# 1992 - 1993 Corvette: Service Bulletin: Noisy/Fraying Accessory Drive Belt

**Subject:** NOISY/FRAYING ACCESSORY DRIVE BELT (INST. SINGLE-SIDED BELT)

**Model and Year:** 1992-93 CORVETTE WITH 5.7L (LT1) ENGINE

**Bulletin Number:** 93-273-6A

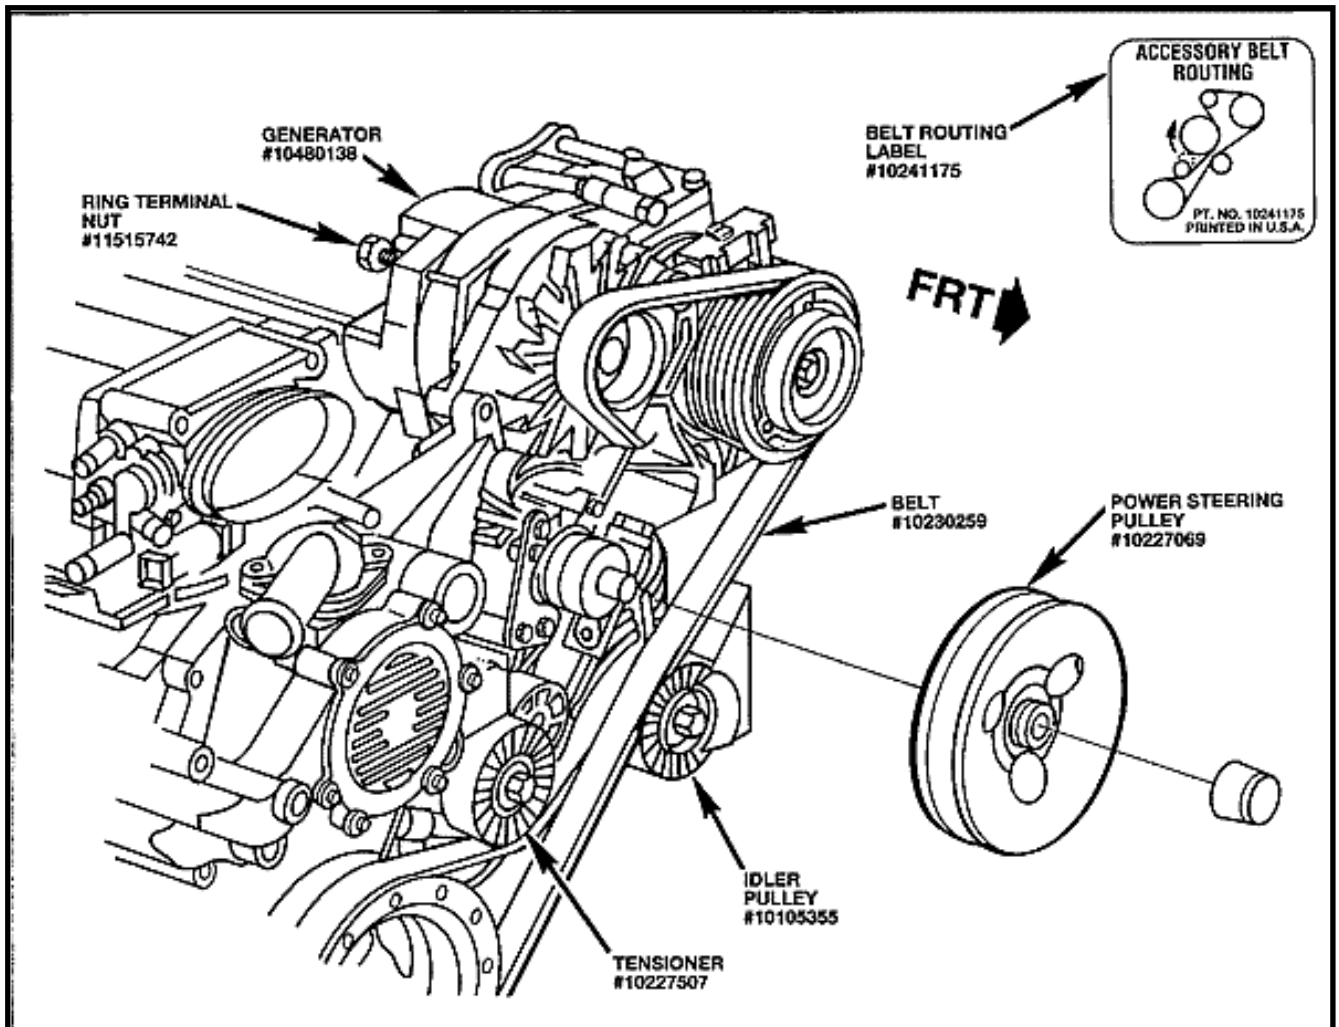
Some owners of 1992 and early 1993 model year Corvettes with 5.7L (LT1, VIN P) engines using the double-sided accessory drive belt may experience a noisy or fraying belt condition.

Inherent stresses and/or processing of the double-sided belt.

To correct this condition a change was made from the double-sided belt system to a new single-sided belt system. Starting the week of March 22,1993, VIN breakpoint #1G1YY23P4P5113150 Corvettes with LT1 engines were built with the new single-sided belt. To repair older units with the double-sided belt to a single-sided belt, the following parts must be installed:

- 10227507 Tensioner
- 10227069 P/S Pulley
- 10105355 Idler Pulley
- 10463533 Generator
- 11502811 Generator Ring Terminal Nut #M8

**NOTE:** When replacing the new generator, the ring terminal on the wire harness will have to be opened up the 8.5mm to accommodate the larger stud on the back of the new generator.
